ELECTRONICS FIELD CHANGE BULLETIN  
 NAVAL SHIP ENGINEERING CENTER  
 WASHINGTON, D. C. 20360

27-AN/URC-32  
 13-AN/URC-32A  
 10-AN/URC-32B  
 18-KWT-6(8)

INSTALLATION OF STANDBY AND EMITTING STATUS MONITORING RELAYS

**PURPOSE:** To provide equipment STANDBY and EMITTING functions to the AN/SSQ-54 Emitter Status Indicator Set.

FIGURE 1.

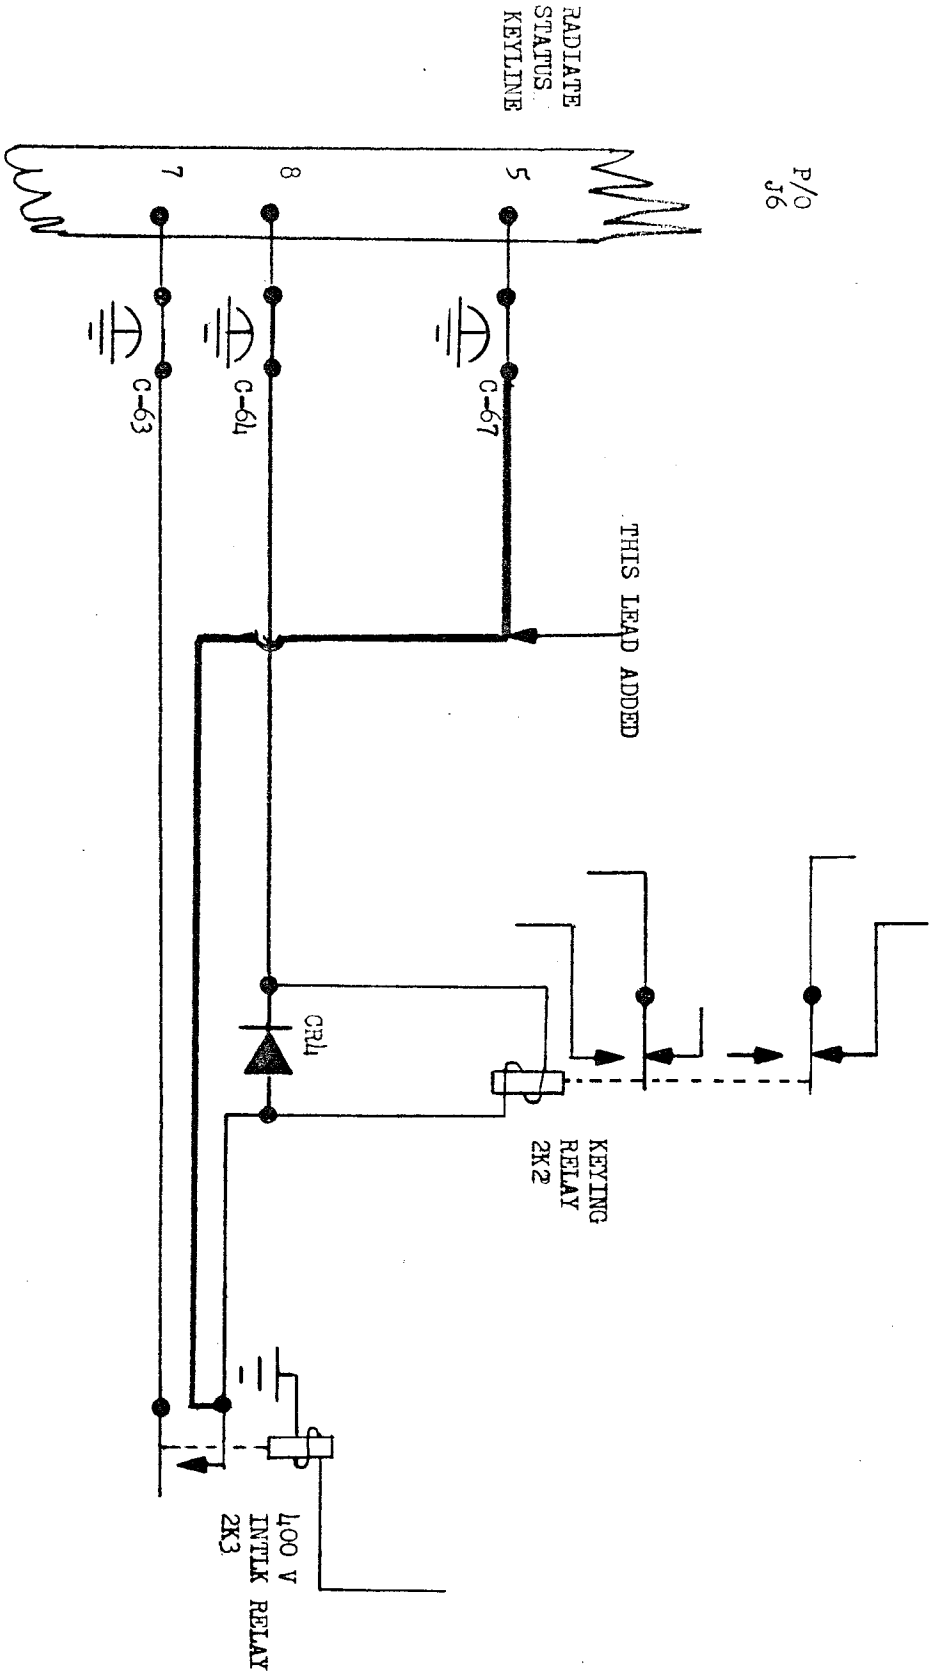
7. Refer to figure 1 of this bulletin which is a partial schematic of the AM-2061/URT taken from the main AM-2061/URT schematic in NAVSHIPS 0967-066-7010, Volume 1, Figure 5-99. (Formerly NAVSHIPS 93285-B, Volume 1, Figure 5-99). Figure 1 shows the addition of a lead between feed-thru capacitor C67 and the stationary contact of Relay 2K3.

9. Solder the 10" piece of black No. 20 AWG hook-up wire in item 4 of material procured to the stationary contact of 2K3. (NOTE: If the contact terminal is heated with the 47½ watt soldering iron, the terminal hole can be opened with a toothpick. The lead can then be hooked into the hole and soldered without removing Relay 2K3)

10. Route the added lead over to the existing cable harness going to the capacitor feed-thru terminal box. Run the lead up the harness. Connect and solder to feed-thru Capacitor C67.

FIGURE 2.

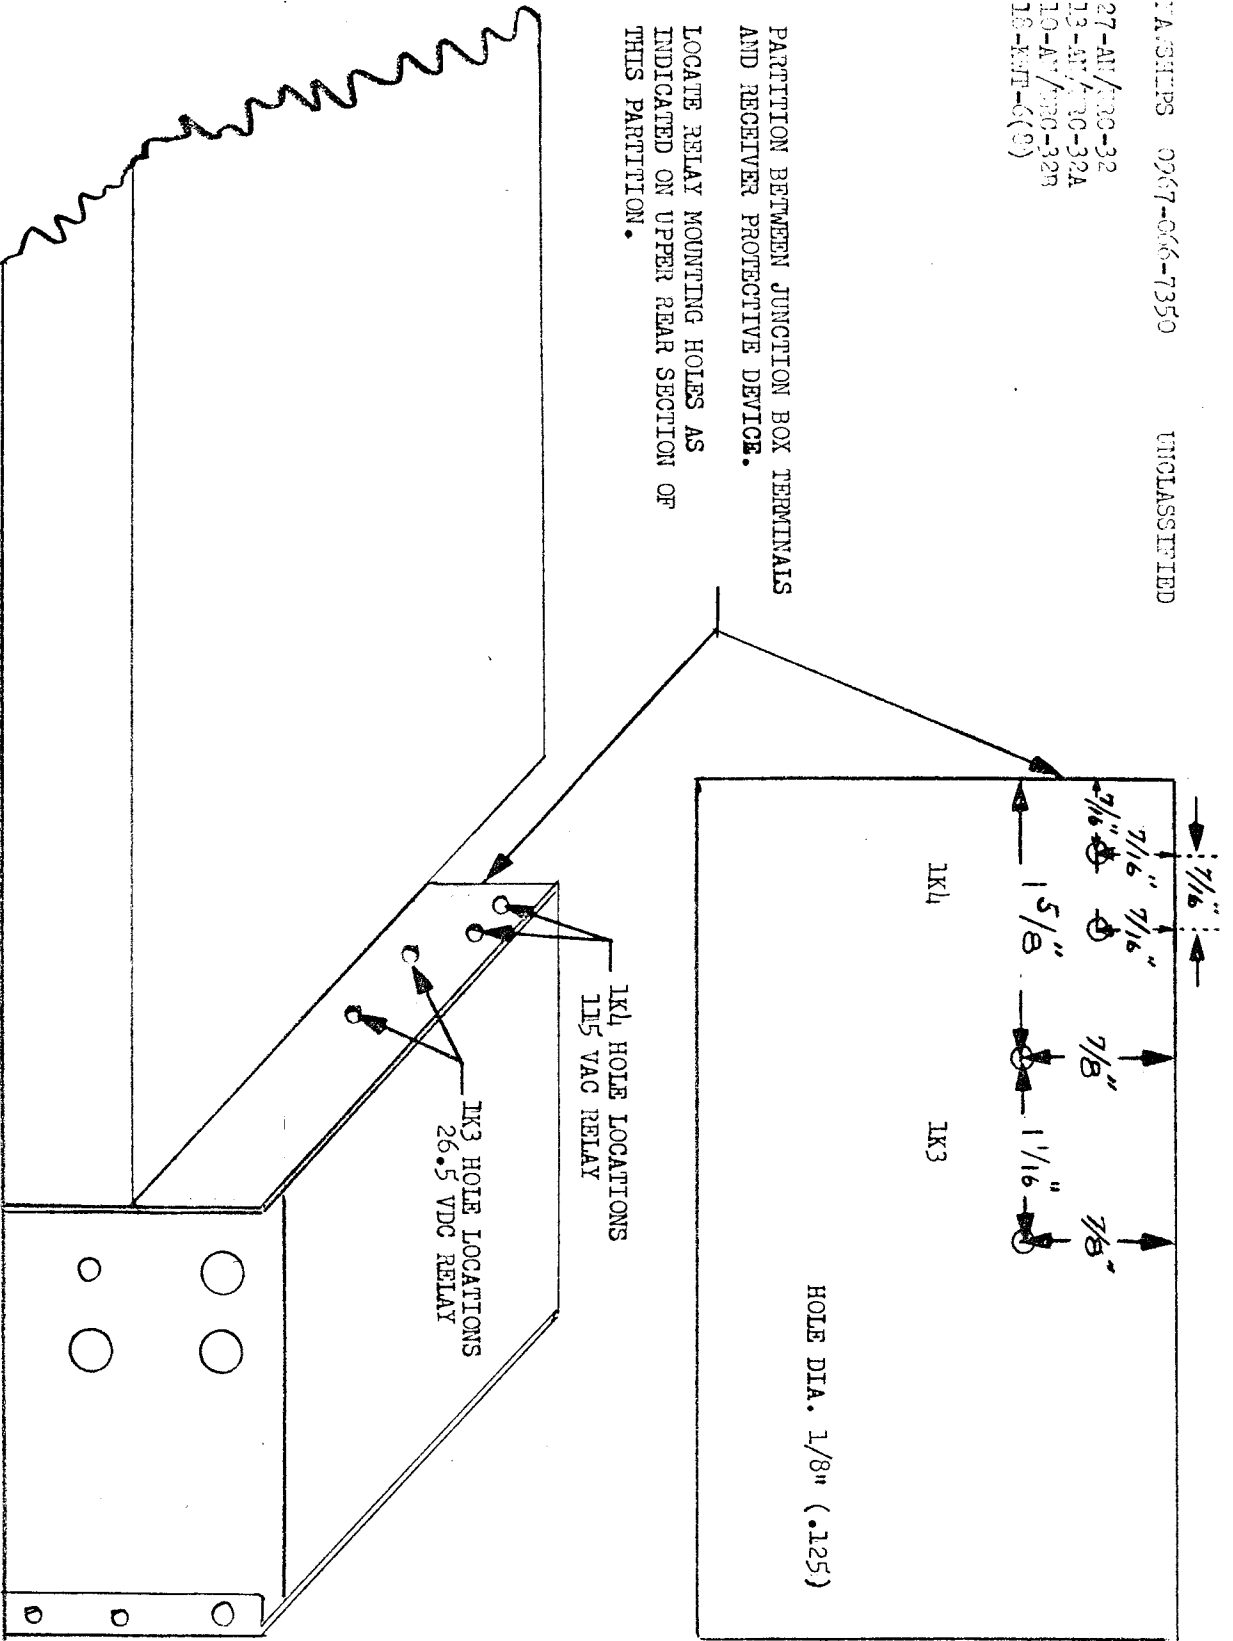
3. Refer to Figure 2 of this bulletin. Locate the drill the mounting holes for Relay 1K3 (26.5 VDC) and Relay 1K4 (115 VAC), as per instructions on the figure.

LOCATE RELAY MOUNTING HOLES AS INDICATED ON UPPER REAR SECTION OF THIS PARTITION.

FIGURE 3.

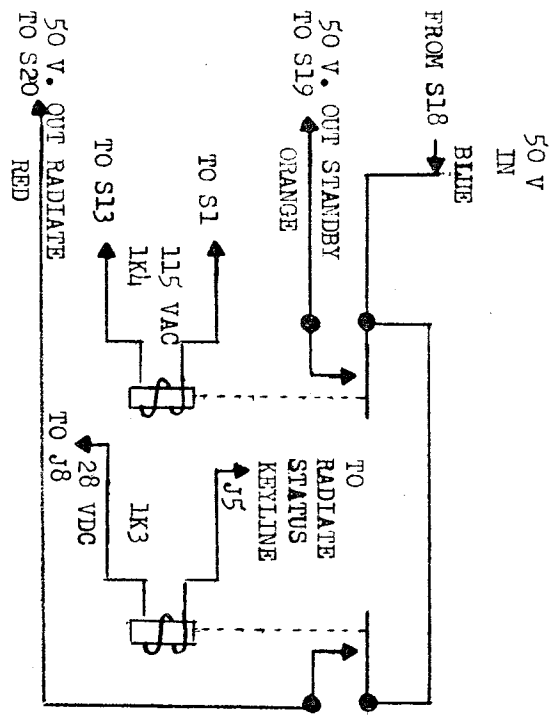
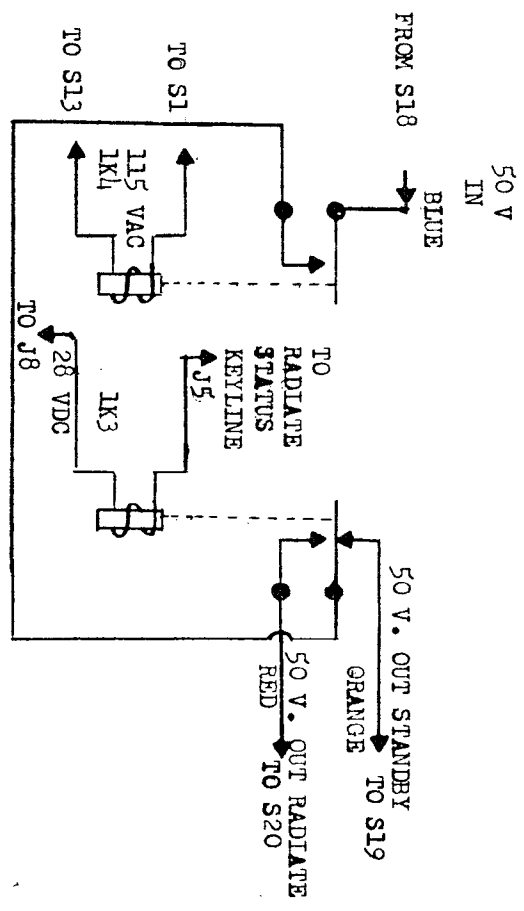
6. The AN/SSQ-54 Status Indicating Equipment will supply a "Signal In" (50 V) to the AN/URC-32( ) which returns the "Signal In" to the AN/SSQ-54 as "STANDBY" or "RADIATE" condition signals. Refer to Figure 3 and determine which relay hook-up the installation requires.

a. Option 1 relay hook-up will apply 50 volts out on the ORANGE STANDBY line when the AN/URC-32( )'s power switch "S1" on the low voltage power supply is placed in the "ON" position. When the "PLATE ON-OFF KEY" switch on the AM-2061/URT is placed in the "ON" position with the "FIL-OFF-TUNE/OPERATE" switch in either "TUNE" or "OPERATE" and the AN/URC-32( ) is keyed, 50 volts will be applied to the red radiate line also. A radiate

condition will be indicated by the presence of 50 volts on both the orange and red lines simultaneously.

b. Option 2 relay hook-up will apply 50 volts out on the orange standby line when power switch "S1" on the low voltage power supply is placed in the "ON" position. When the "PLATE ON-OFF KEY" switch on the AM-2061/URT is placed in the "ON" position with the "FIL OFF-TUNE/OPERATE" switch in either "TUNE" or "OPERATE" and the AN/URC-32( ) is keyed. The 50 volts on the orange line will be switched to the red radiate line. A radiate condition will be indicated by the presence of 50 volts on only the red line. Standby is indicated by the presence of 50 volts on the orange line only.

STANDBY - 50 V. OUT ON ORANGE LEAD ONLY.

RADIATE - 50 V. OUT ON BOTH THE ORANGE AND RED LEADS SIMULTANEOUSLY.

STANDBY - 50 V. OUT ON ORANGE LEAD ONLY.

RADIATE - 50 V. OUT ON RED LEAD ONLY.

FIGURE 4.

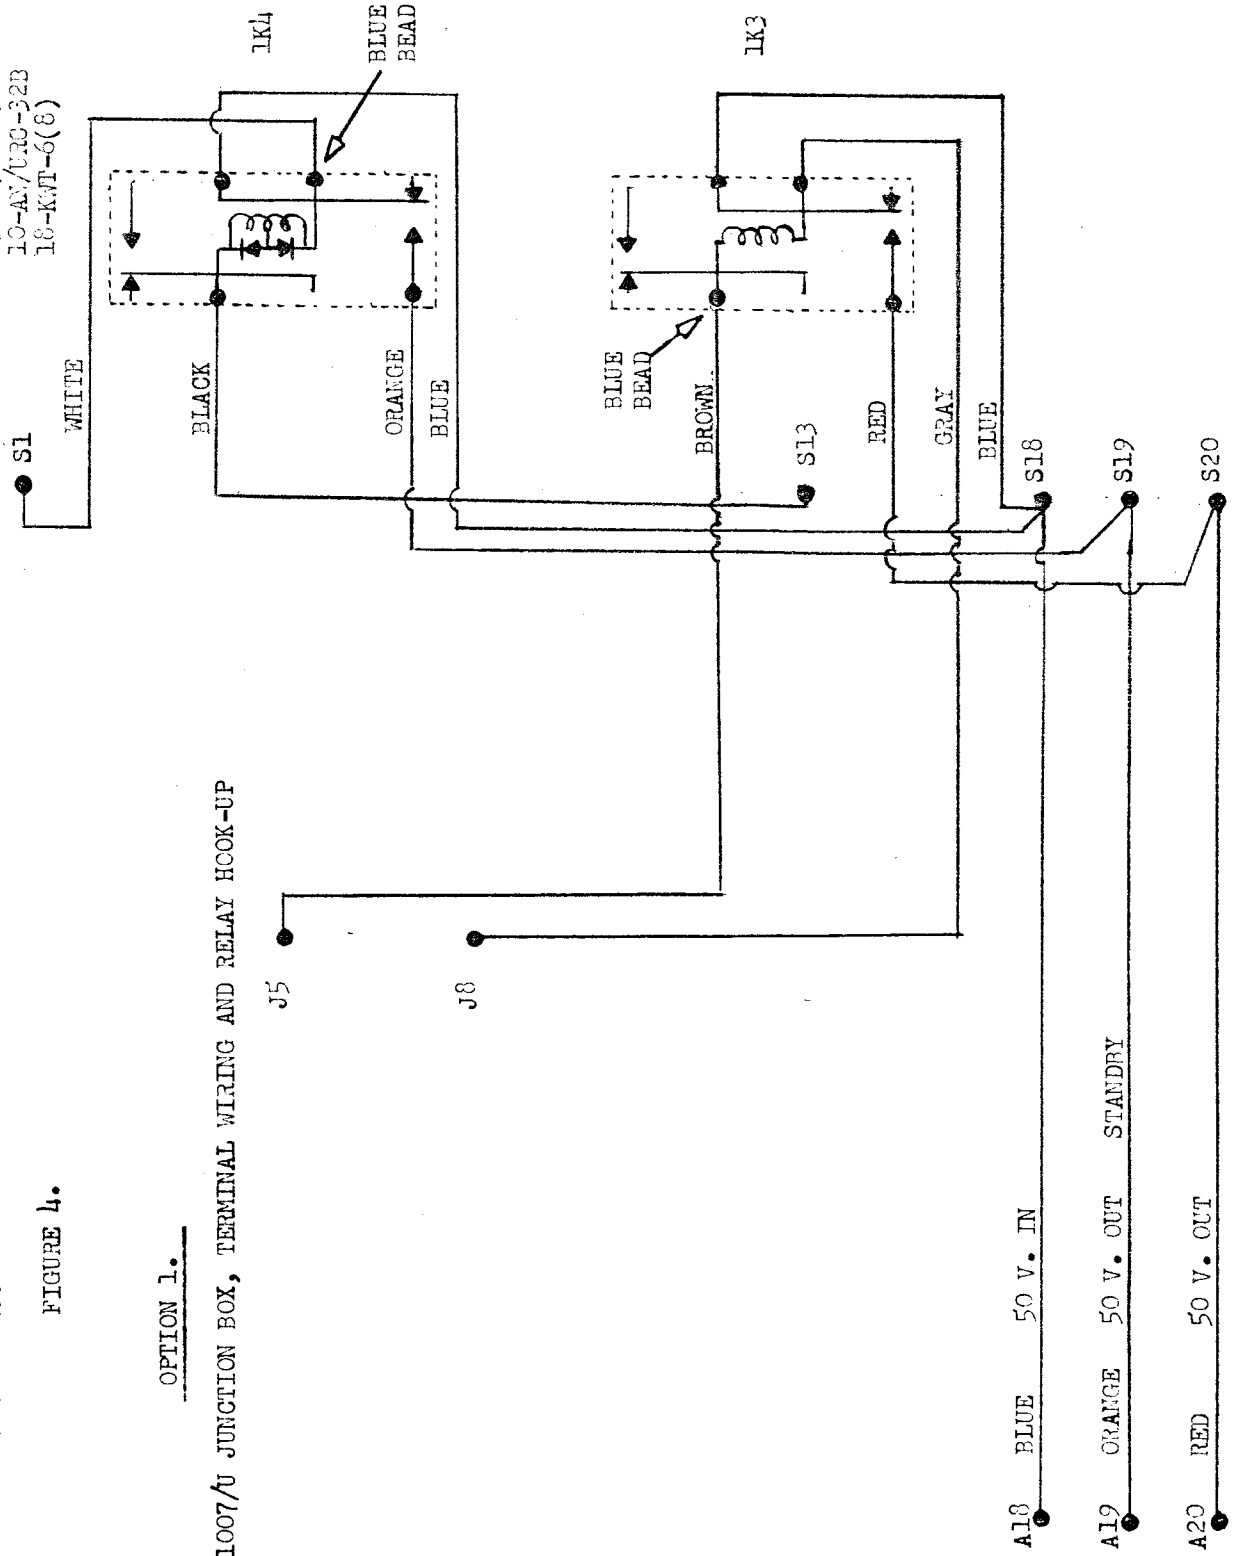
d. After determining which relay hook-up the installation requires, refer to Figure 4 for Option 1 Relay Hook-Up, or refer to Figure 5 for Option 2 Relay Hook-Up. Junction Box, J-1007/U wiring is the same for either option.

7. Make the relay hook-ups and J-1007/U Junction Box wiring connections as indicated in either Figure 4 or 5. On each wiring connection to the terminals of 1K3 and 1K4 slip a piece of sleeving over the lead before making the connection. After soldering, slip the sleeving over the soldered terminal connections.
